Project Advisory Committee (PAC) - Meeting #1 Meeting Summary

On March 20, 2017 the City of Hillsboro Parks & Recreation Project Team met with the Project Advisory Committee (PAC) for the Crescent Park Greenway Trail Plan. The PAC was selected to provide perspective and expertise from a broad range of stakeholders, community advisory boards and professional staff. Members were either appointed by their respective agency or through a formal request at board meetings.

PAC Meeting # 1 Summary

McKay Creek Area 5 - Trail Alignments

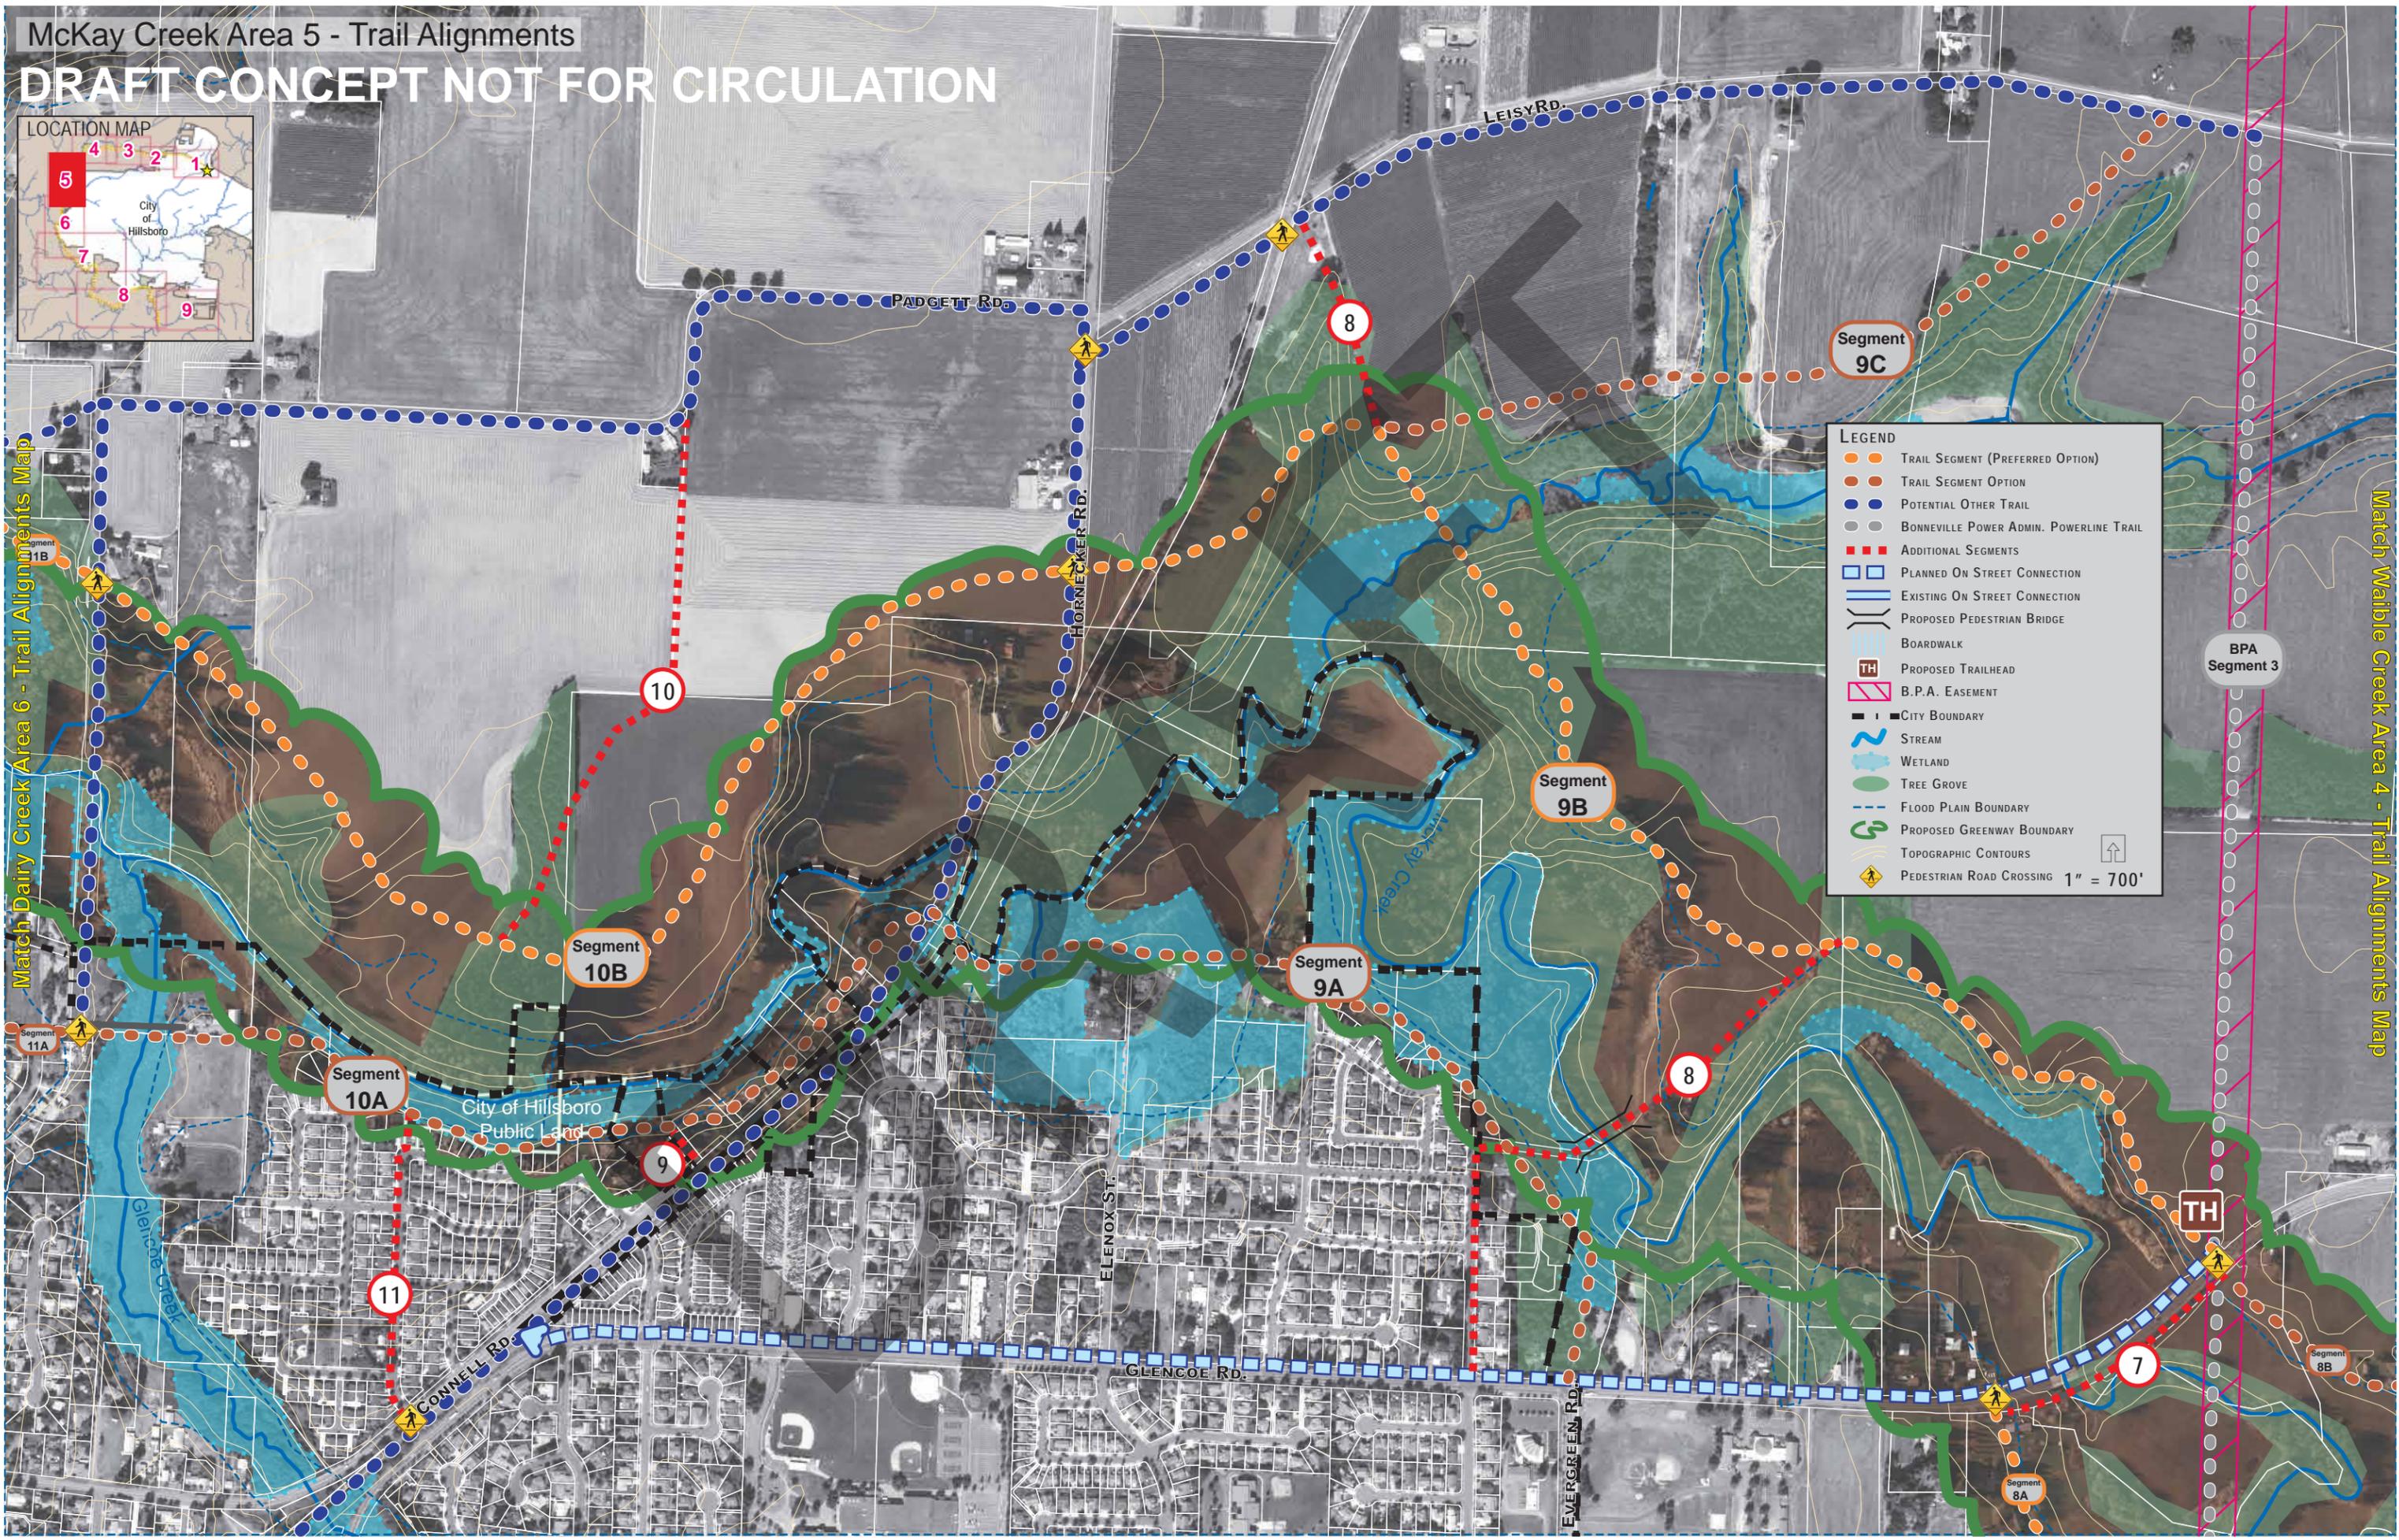
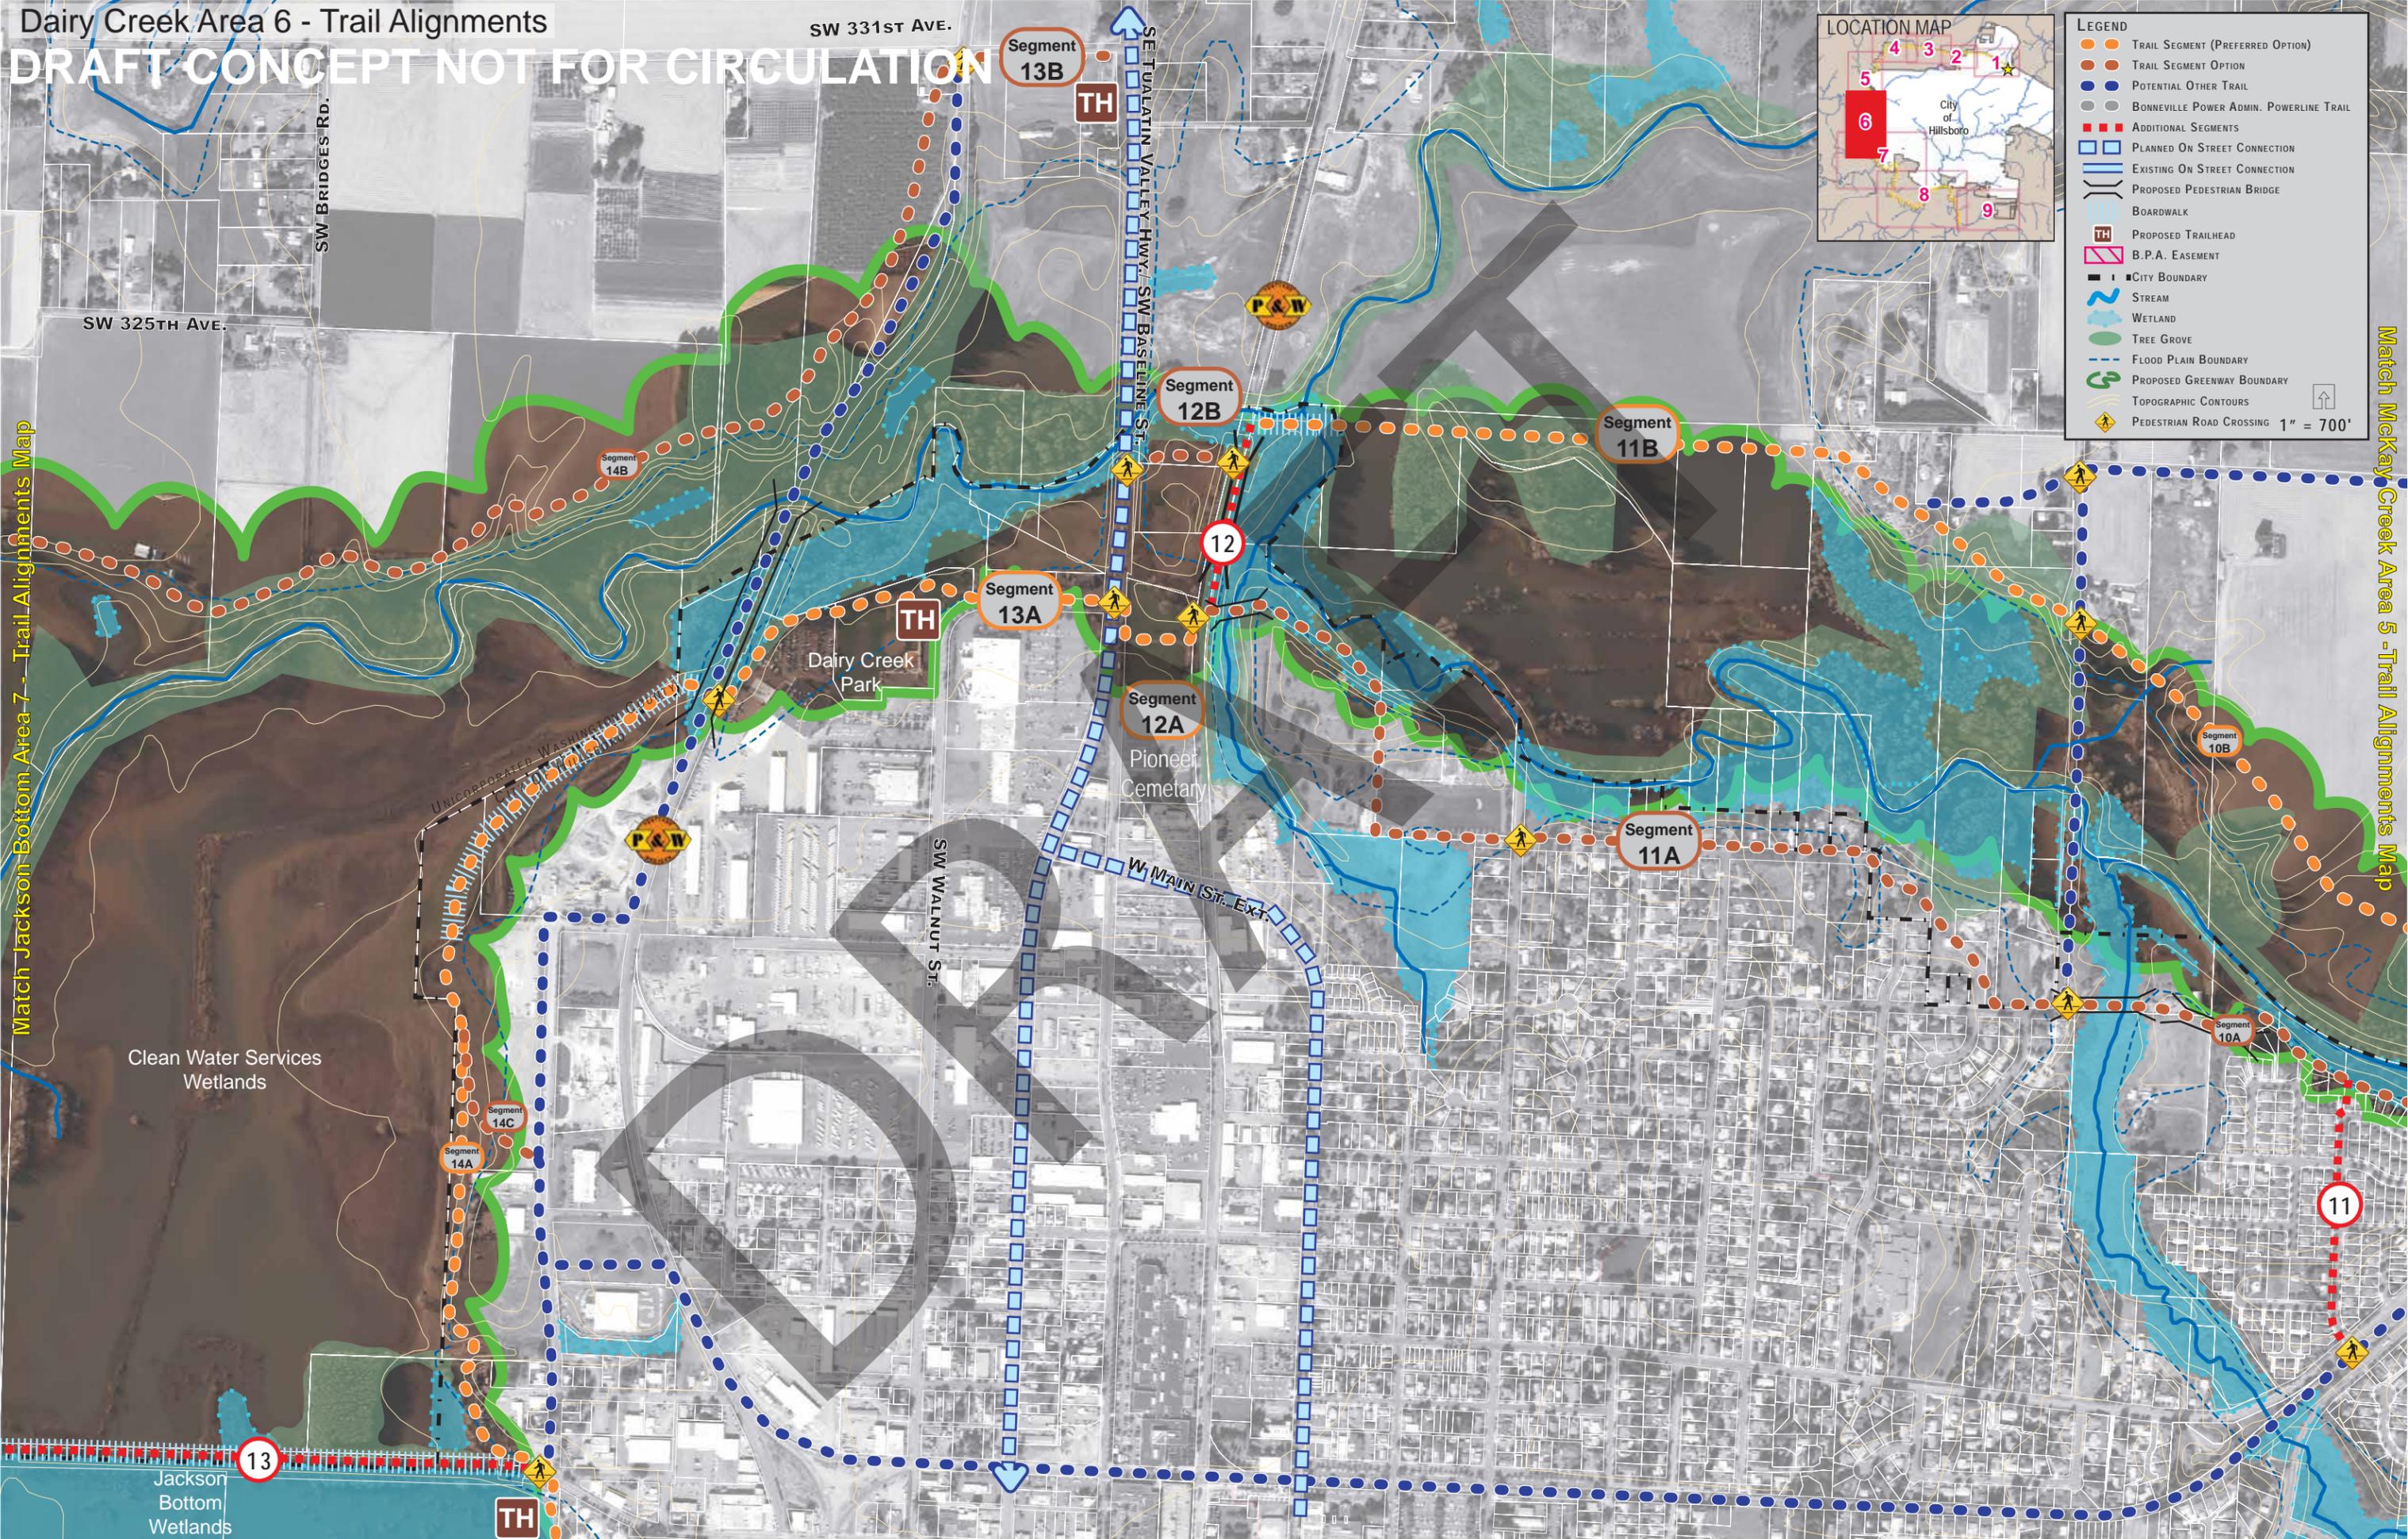
- Make connection from CPG to Connell on street facilities at Cory Street. (See map from PAC Meeting).
- Reclassify and bump “other trail” along Connell alignment as planned on street connection. Adjust to match Wa. Co. and Hillsboro TSP’s.
- Look into possible partnerships and properties Swallowtail Education Center and Boy Scouts of America Camp Ireland.
- Keep alignment through agricultural areas and work with PAC Members to identify key stakeholders such as Clean Water Services.
- Add other regional trail alignments to map such as North Plains connection and Council Creek Regional Trail.
- Work with Wa. Co. to identify roadway connections for alternate alignments and loops.
- Remove other trail alignment in active rail corridor.
